NEW HOUSE FOR MR AND MRS JAKICH
AT 26 BIRKDALE RD, BIRKDALE
DRAWN MARCH 1997

NEW HOUSE FOR MR AND MRS JAKICH
AT 26 BIRKDALE RD, BIRKDALE
DRAWN: MARCH 1997

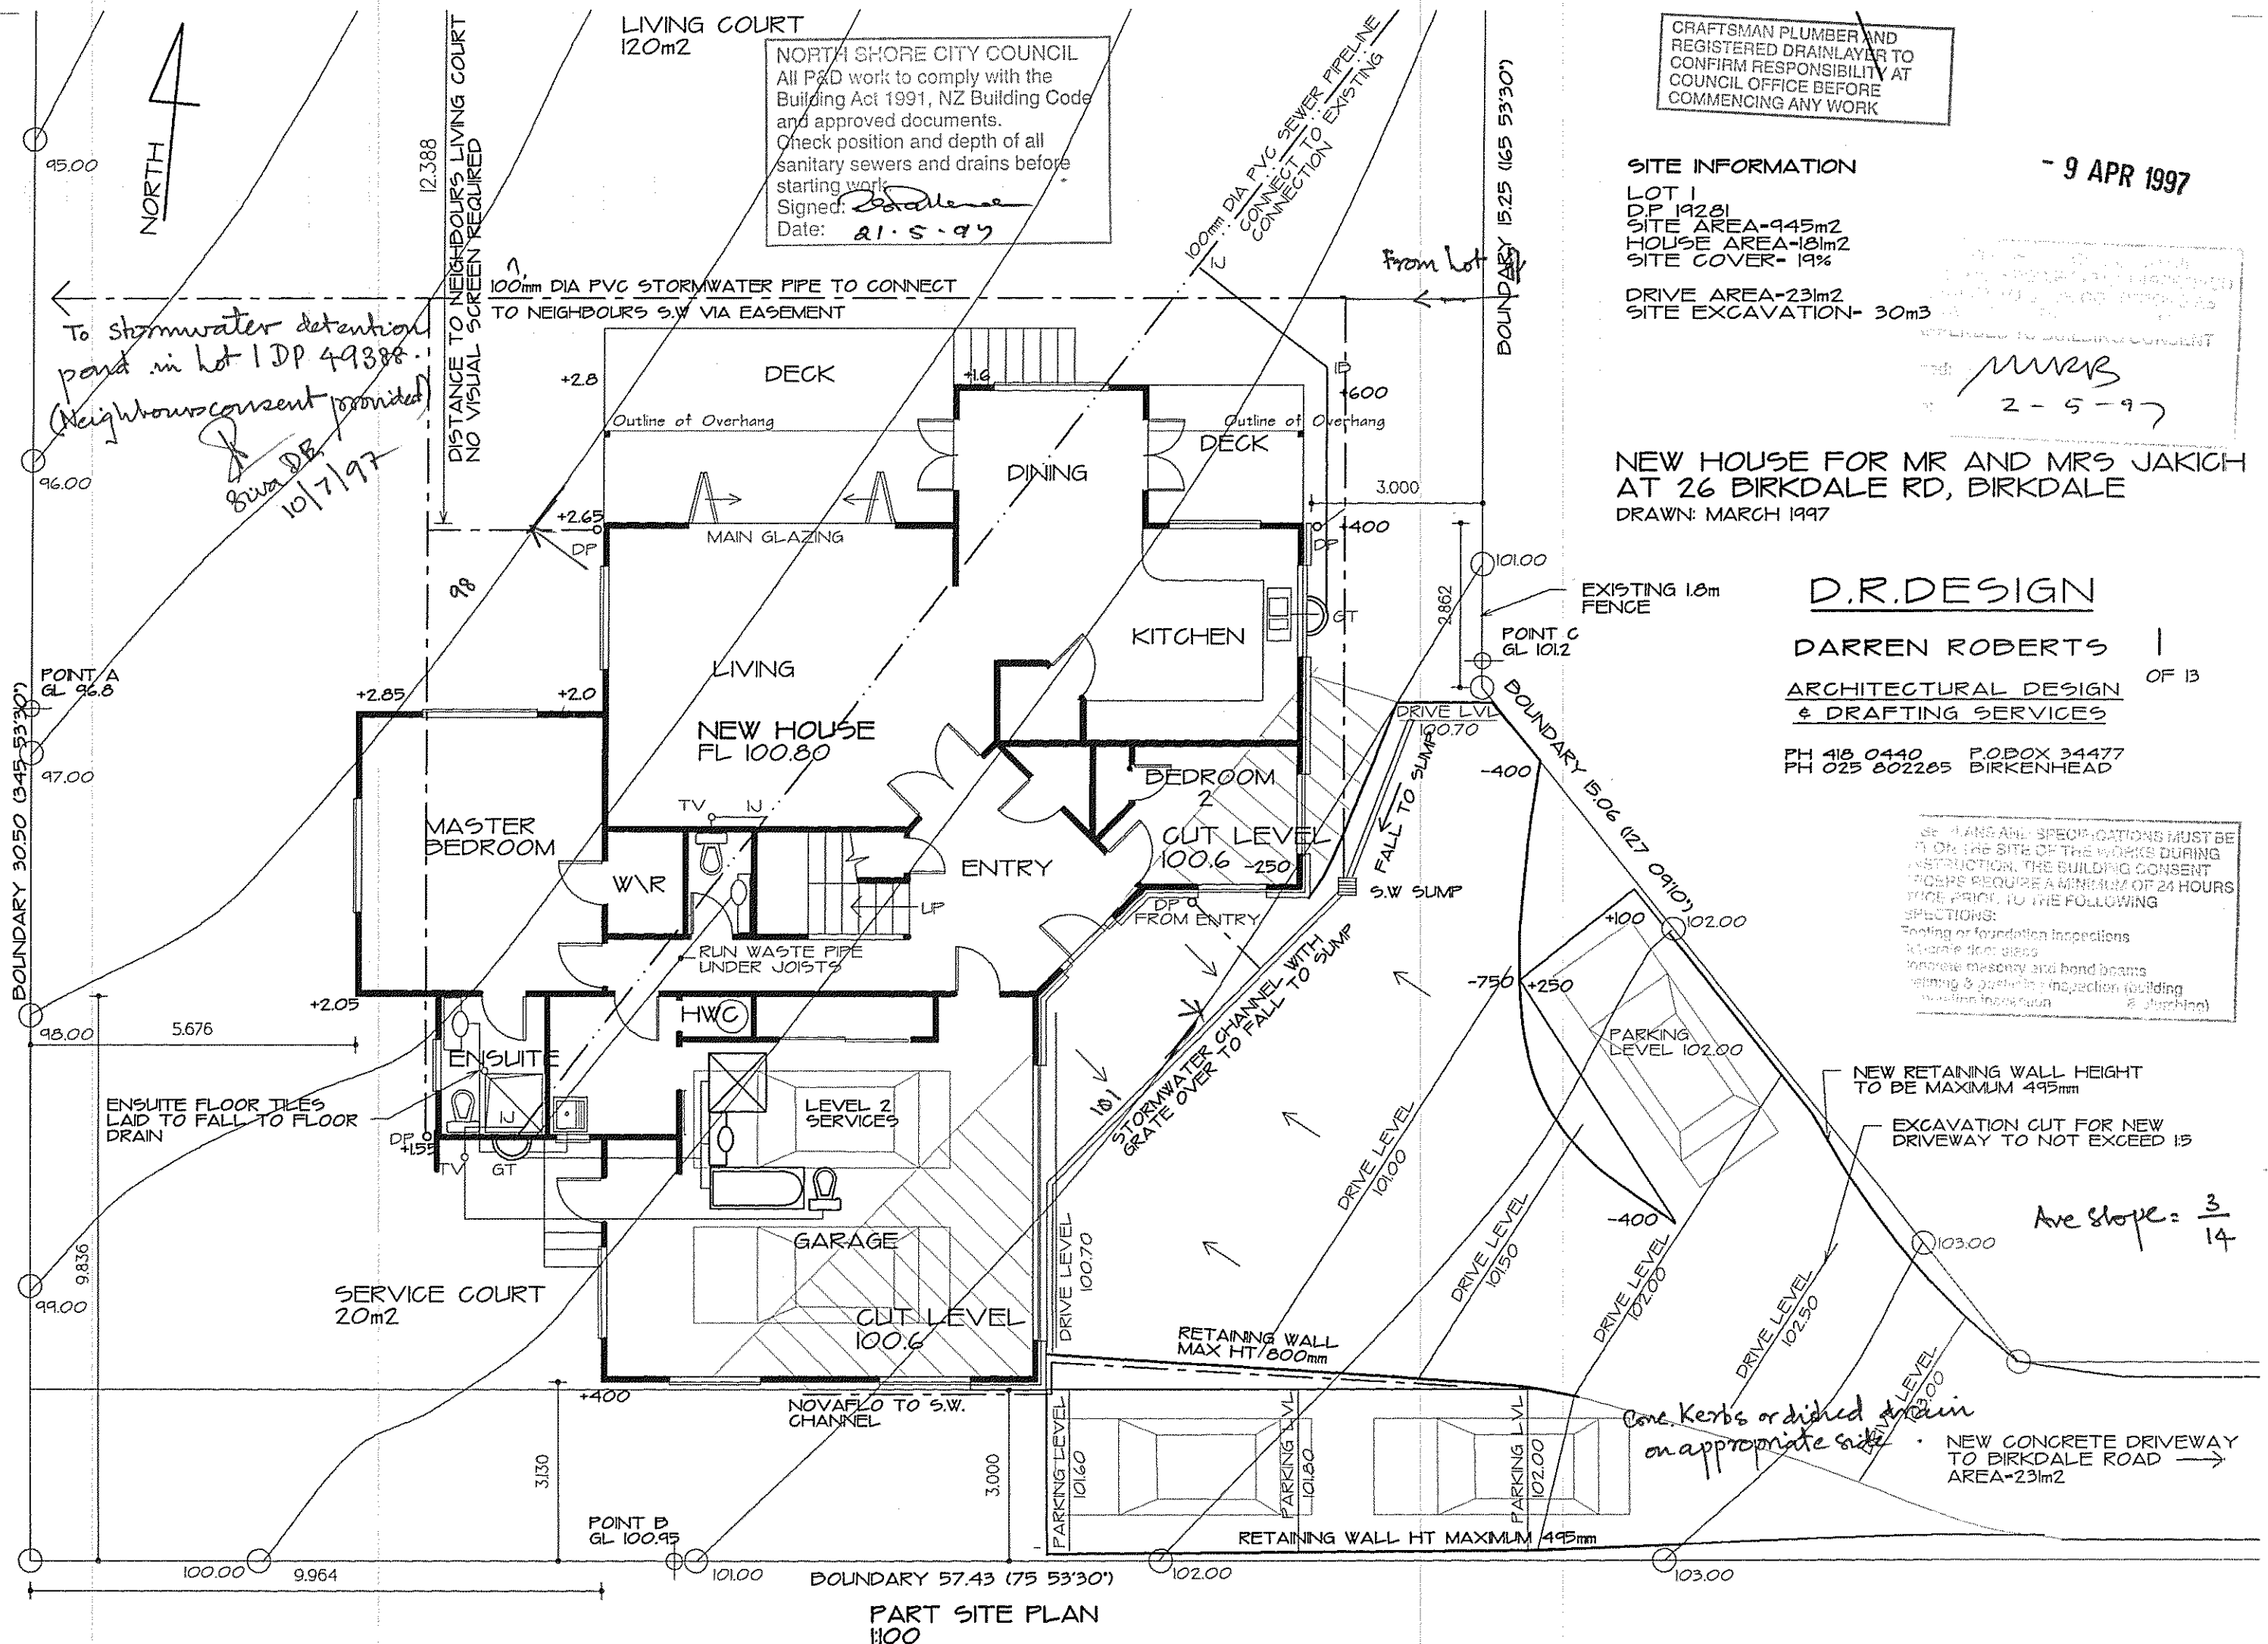
- NEW RETAINING WALL HEIGHT
TO BE MAXIMUM 495mm

— EXCAVATION CUT FOR NEW DRIVEWAY TO NOT EXCEED 1:5

SITE PLAN
SHOWING VISUAL PRIVACY
1:200

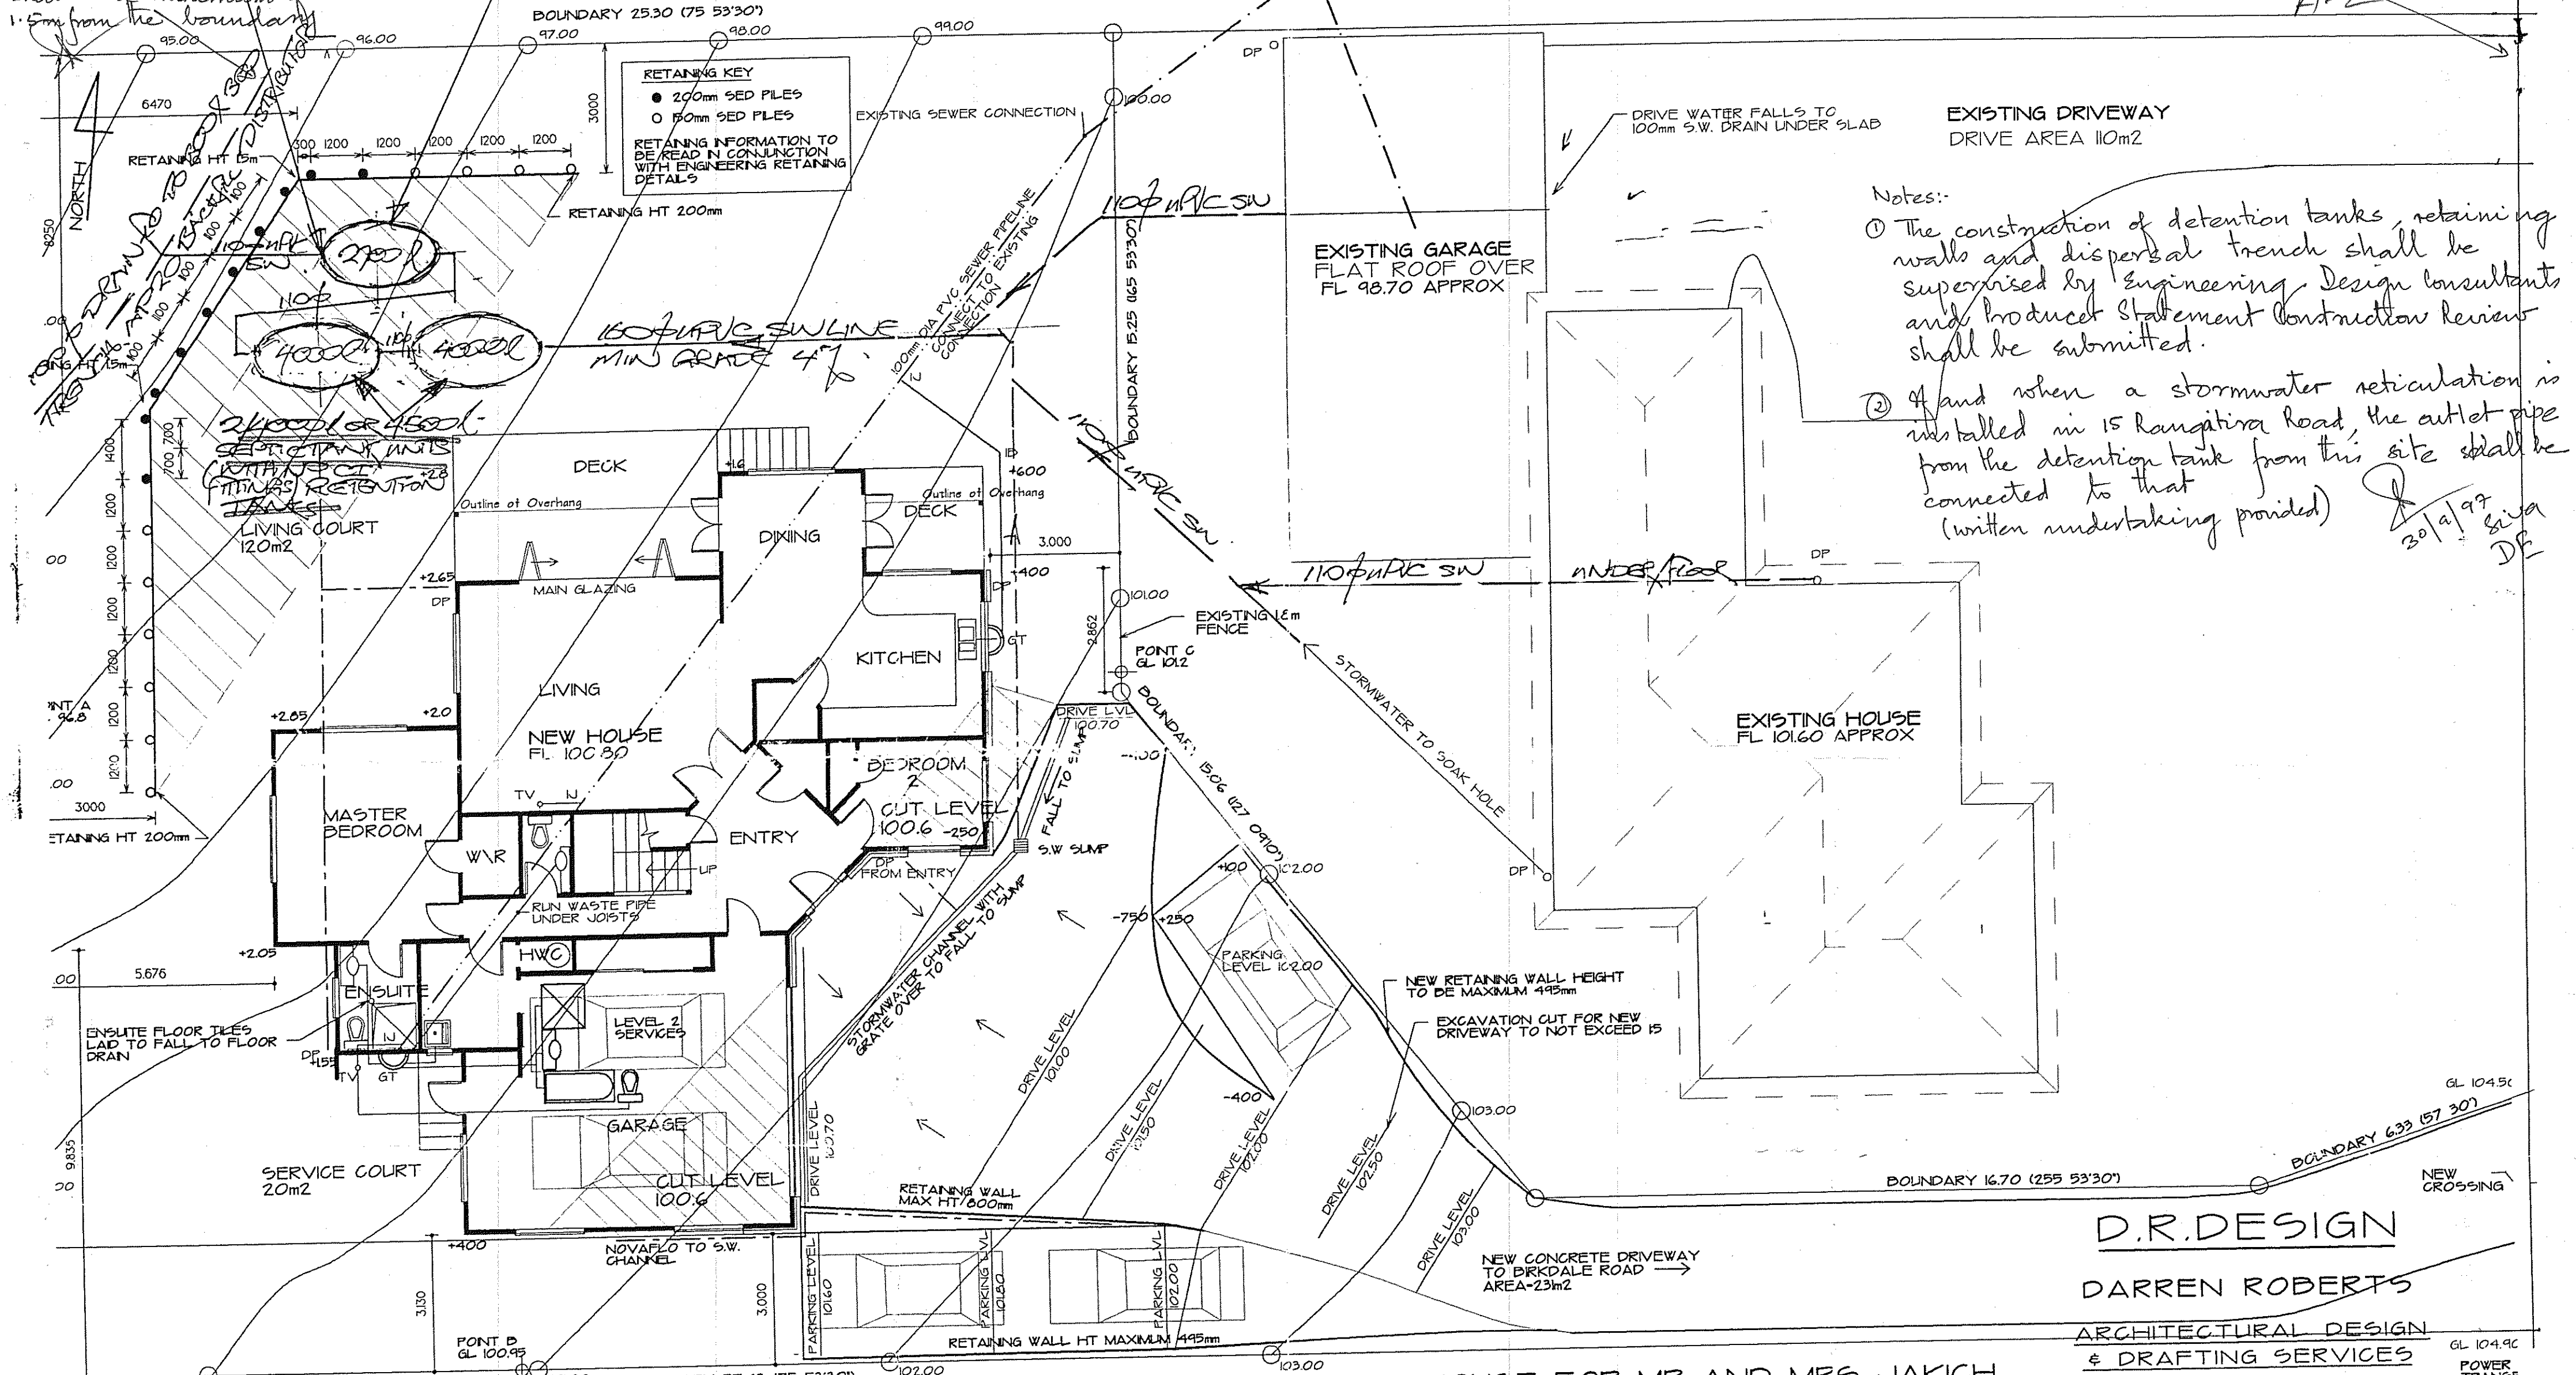
Note :: Regarding s/w drainage from lots 1 & 2, please refer to details on sheet no. 14

20
SQUARE
LIVING COURT
120m2
Refer Sheet No 14

Street opening notice application shall be made for carrying out any works on road reserve + footpaths.

37mm Ø ORIFICE
PLATE
Dispersal trench outlet shall be a minimum of 1.5m from the boundary
